Access Compliance Report Public Rights-of-Way (Curb Ramps)

Intersection ID: 28401 Main Street: WADE_ARDREY_RD Cross Street: MARVIN_RD Location: SE **Overall Compliance: No** ADA ID: 67AEA4369822 Ramp Type: Perp Initial Pass/Fail: Fail **Severity Score:** 12.5

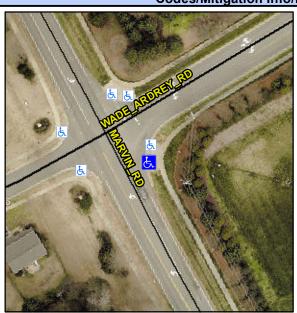
è	Possible Solutions:
	Remove & Replace Entire Ramp.
é	
200	
Section 2	Surveyor Notes:
	N/A
į	
The same	
	PROW/ADA:
	Not Found, R304.5.3
ě

Field Measurements/Component Compliance								
Compliance Description Da		Data	Comp	liance	Description	Data		
N/A	Ramp Length (in)	134.0	Yes	Ramp	Slope (%)	5.1		
Yes	Ramp Width (in)	48.0	No	Ramp	XSlope (%)	5.9		
N/A	Flare Type LT	N/A	N/A	Flare	Type RT	N/A		
N/A	Flare Slope LT (%)	N/A	N/A	Flare	Slope RT (%)	N/A		
N/A	Flare Traversable LT?	N/A	N/A	Flare	Traversable RT?	N/A		
N/A	Landing Length (in)	N/A	N/A	DWS	Provided?	N/A		
N/A	Landing Width (in)	N/A	N/A	DWS	Contrast?	N/A		
N/A	Landing Slope (%)	N/A	N/A	DWS	Length (in)	N/A		
N/A	Landing X Slope (%)	N/A	N/A	DWS	Full Width?	N/A		
N/A	Landing Curb? (Y/N)	N/A	N/A	DWS	Offset (in)	N/A		
N/A	Shared Landing?	N/A						
N/A	Gutter Ponding?	N/A	N/A	Gutte	r Slope (%)	N/A		
N/A	Gutter Lip Ht (in)	N/A	N/A	Gutte	r X Slope (%)	N/A		
N/A	Painted X Walk1?	No	N/A	Paint	ed X Walk2?	N/A		
	X Walk 1 Direction	To SW		X Wa	lk 2 Direction	N/A		
N/A	X Walk 1 Width (in)	N/A	N/A	X Wa	lk 2 Width (in)	N/A
